**SOUTHERN CALIFORNIA GAS COMPANY (SOCALGAS)
SIERRA CLUB-SCG-06
WOODY BIOMASS PILOT PROJECT APPLICATION (A.25-10-008)
DATE REQUESTED: April 16, 2026
RESPONSE DUE: April 30, 2026**

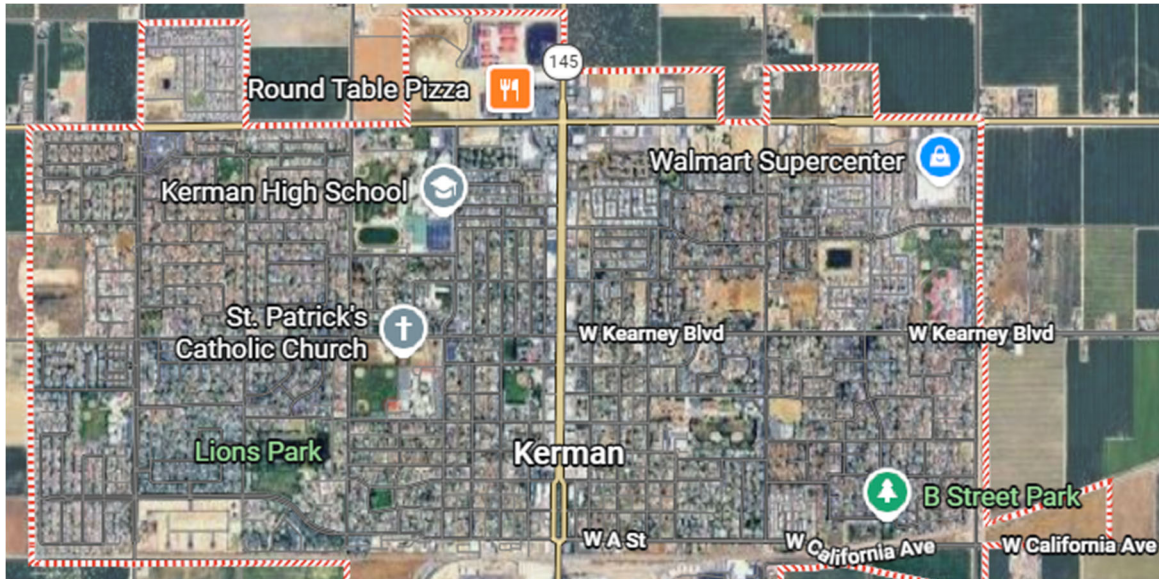
Please provide the geographic coordinates of the “populated areas” and the “population center” to which SoCalGas refers in Rebuttal Testimony at JLMS-29 and JLMS-30, respectively. Please indicate the witness responsible for this answer.

Below provides the location of the populated areas/center of the City of Kerman. An example of one geographic coordinate is 36.72756493376932, -120.06664485083795 (St Patrick’s Catholic Church). Dr. Matthew Summers is the witness.
